Date issued: December 16, 2005

Subject: Treatment of Ice Maker Volume in Accordance with ANSI/AHAM HRF-1-2004.

Photograph provided:

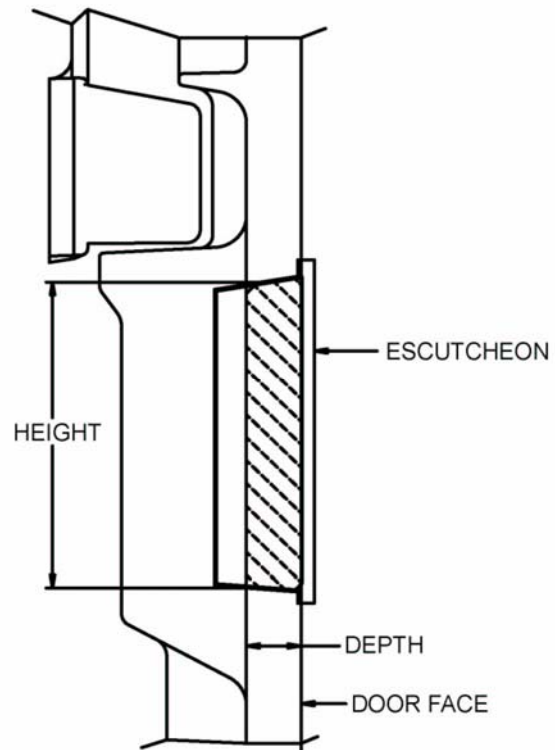
Staff response: Not the whole volume marked on the photographs. In the photographs provided, the edge of the fountain aperture has been marked as the limit of the measured volume. This is incorrect. The volume of the fountain cavity forward of the plane of the door front surface may not be included. Please refer to the third sentence of the second paragraph of 4.2.1.1(a), "Include that portion of the volume of the fountain cavity extending to the door front surface (between the inner door liner and outer door face) even though that volume is forward of the door liner."

Furthermore, from review of fig. 4-18 it is not permissible to include the volume of any sump below the level of the bottom of the aperture between the inner door liner and the door front surface.

Figure 4-18 — Measurement of Icemaker Volume

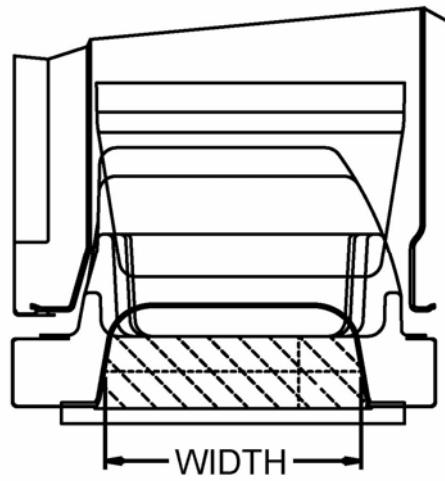
Staff response: Yes. However the volume calculation specified in the second sentence of the second paragraph of 4.2.1.1(a) is “...average height x average width x average depth, or the actual volume as indicated by fig. 4-18.” However, it is not clear to us that the numbers used in your calculation are consistent with the numbers marked on the photographs.
